REMARKS

Response to Office Action Mailed December 19, 2001

FIG. 3A

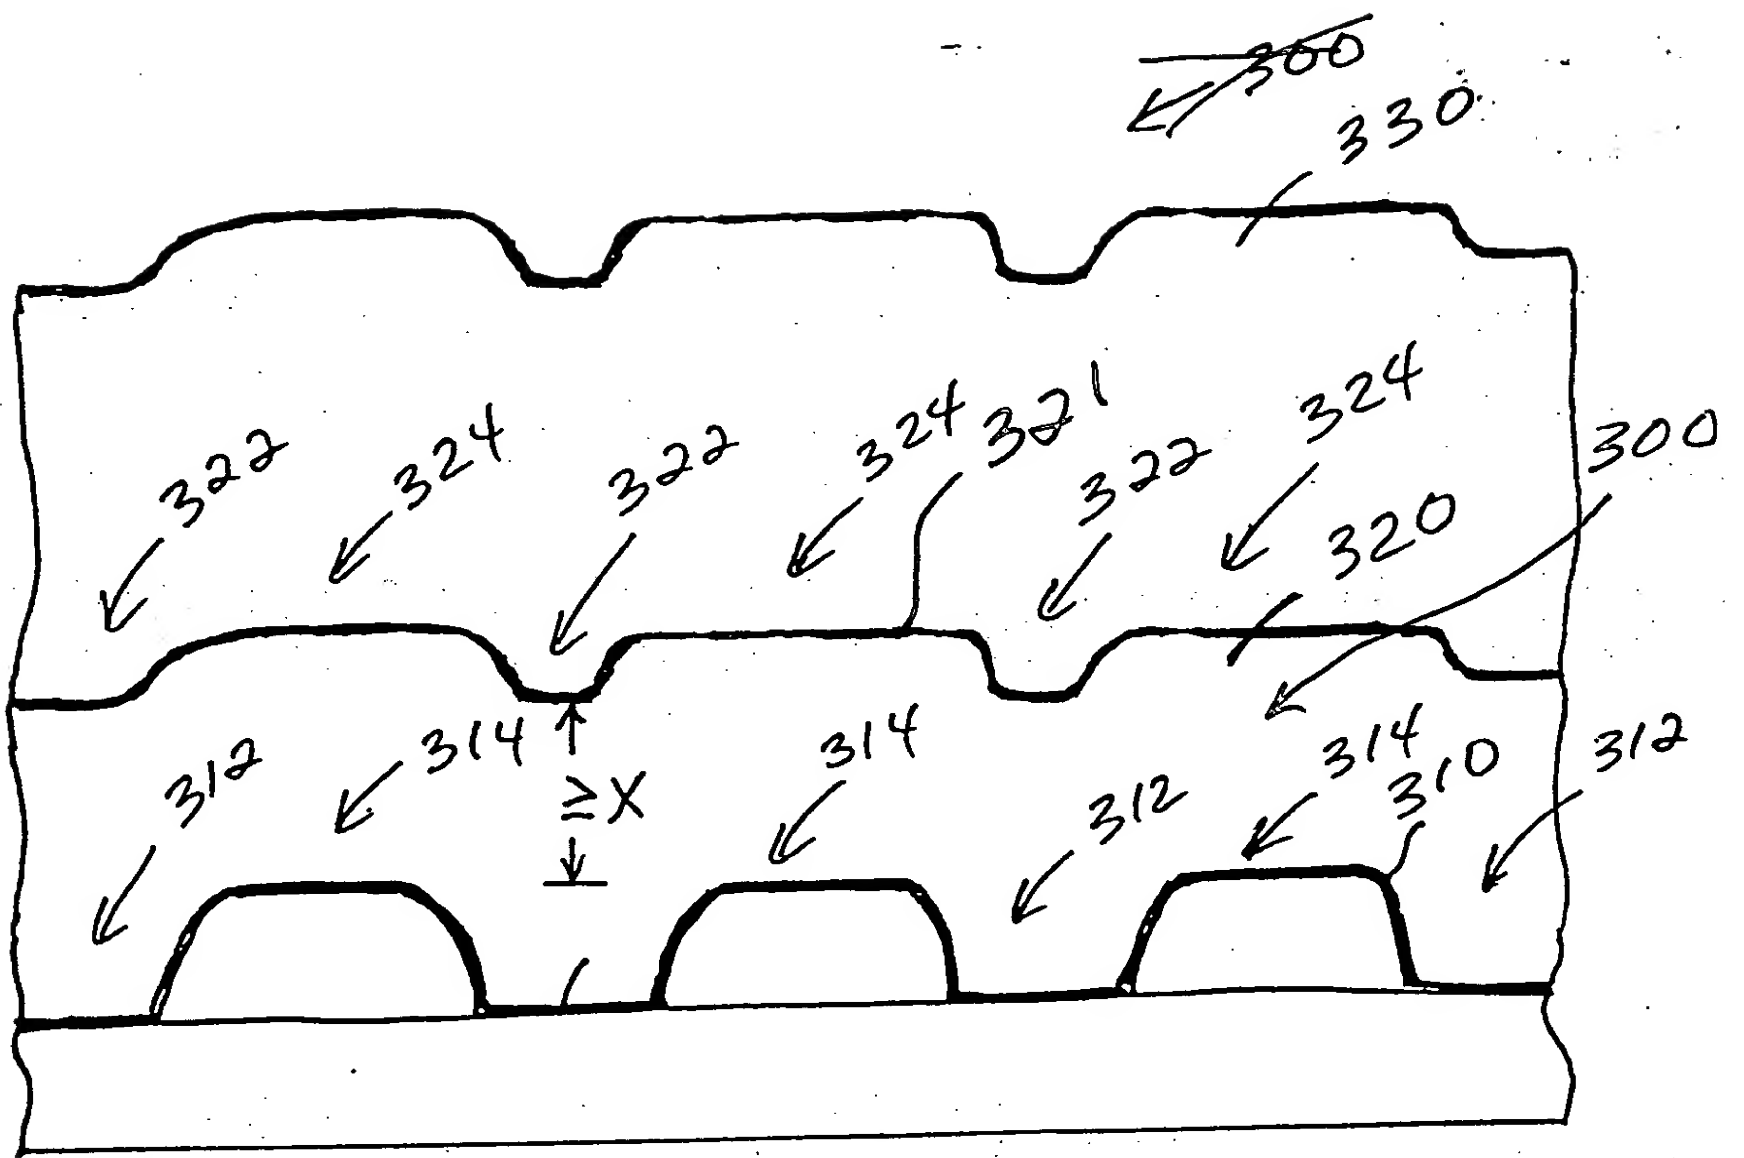
The Examiner objected to the drawings under 37 CFR §1.83(a) as not showing every feature of the invention in the claims. Specifically, the Examiner argued that the phrase “the layer of first material having a top surface” in claim 1 is not shown in the drawings.

Applicant notes that the first layer of material can be read to be, for example, polysilicon layer 320. As shown in FIG. 3A, polysilicon layer 320 has a top surface, although the top surface is not labeled. Thus, to add additional clarity, applicant proposes amending FIG. 3A as shown in red on the attached copy of FIG. 3A to show a top surface 321 of polysilicon layer 320. The specification has also been amended to reflect that the top surface of polysilicon layer 320 is designated by the reference label 321.

The Examiner rejected claims 1-17 under 35 U.S.C. §112, second paragraph, as being indefinite for failing to particularly point out and distinctly claim the subject matter that applicant regards as the invention. Specifically, the Examiner indicated that the phrases “the wafer having a top surface,” “wafer lower level,” and “first material having an upper level” can not be understood because FIG. 3A and the detailed description of FIG. 3A describe wafer 300 as comprehending the entire structure of FIG. 3A. For the reasons set forth below, applicant respectfully traverses this rejection.

Thus, applicant's specification does not teach that the entire structure of FIG. 3A is wafer 300. In an attempt to add further clarity, applicant proposes amending FIG. 3A as shown in red on the attached copy of FIG. 3A by repositioning reference numeral 300.

Please amend FIG. 3A as shown in red on the attached copy of FIG. 3A to add reference label 321 to represent the top surface of polysilicon layer 320, and reposition label 300.

FIG. 3B

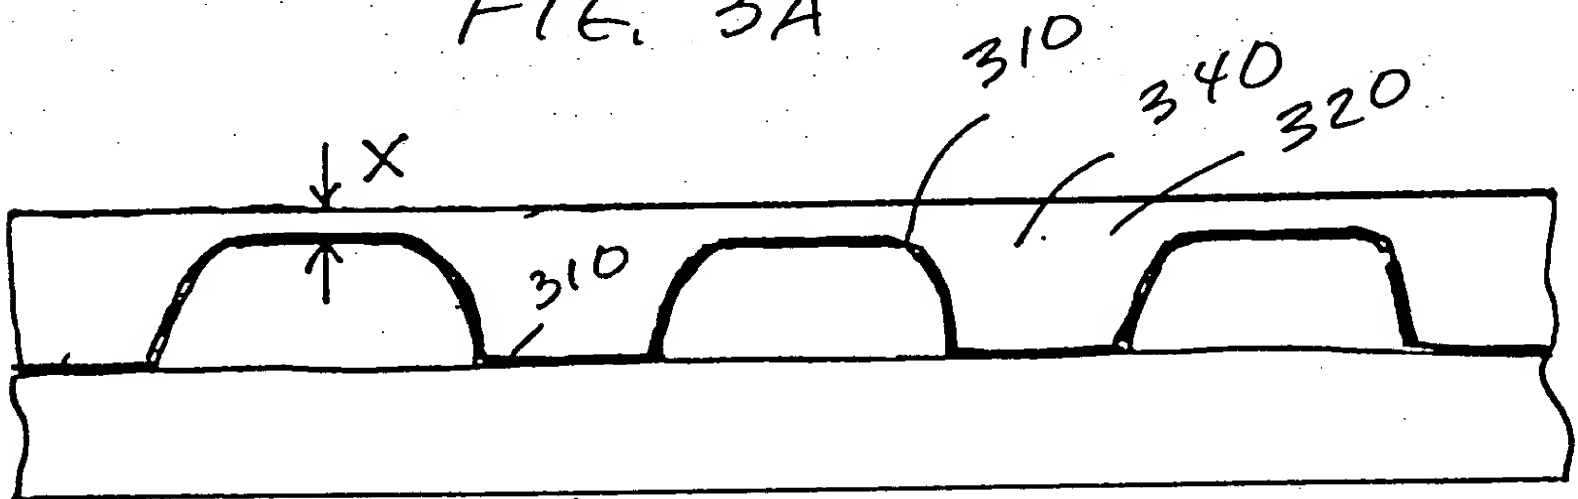
The planarized layer of material can be read to be, for example, planarized polysilicon layer 340. As shown in FIG. 3B, planarized polysilicon layer 340 has a thickness X over the wafer upper level. In addition, FIG. 3A shows that polysilicon layer 320 is formed such that first lower level 322 lies above wafer upper level 314 by a value that is equal to or greater than the thickness X. As a result, claims 5 and 13 are believed to satisfy the requirements of the first paragraph of section 112.

FIG. 3C

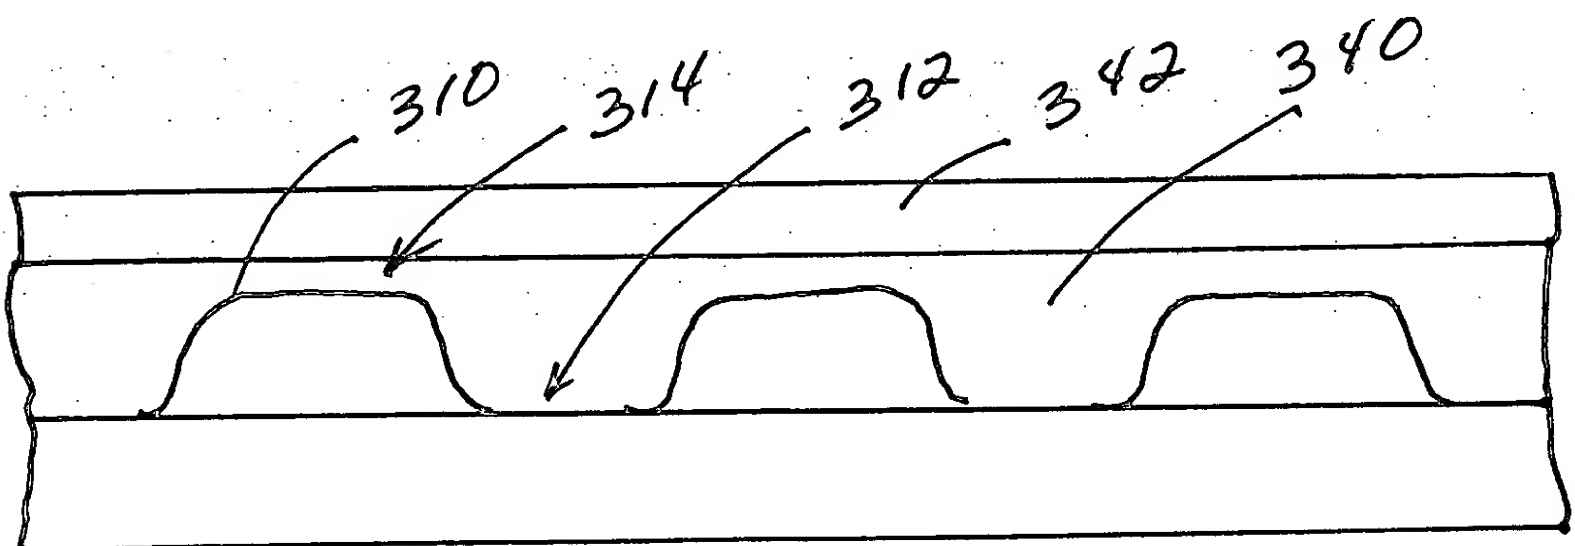
The Examiner also argued that the drawings do not show a third layer of material formed on the planarized layer of material as required by claim 10. As a result, applicant proposes adding FIG. 3C as shown in red on the attached copy of FIG. 3C to show the third layer of material. The specification has been amended to reflect this change. The Examiner further argued that the steps of etching the layer of third material as required by claim 11 are not shown in the drawings. Claim 11 has been cancelled.

Please add FIG. 3C as shown in red on the attached copy of FIG. 3C to illustrate the formation of a layer of material 342.

Alternately, after the planarization step, one or more additional layers of materials, such as materials which lower the resistance of polysilicon, can be formed over layer 340. As shown in FIG. 3C, a layer of material 342 that lowers resistance is formed over planarized polysilicon layer 340. The mask is then formed and patterned on the additional layers of material (e.g., layer 342) which are then etched along with planarized polysilicon layer 340 to form the structures (e.g., local interconnect lines). Either way, once the structures have been formed, the method continues with conventional back-end processing steps.
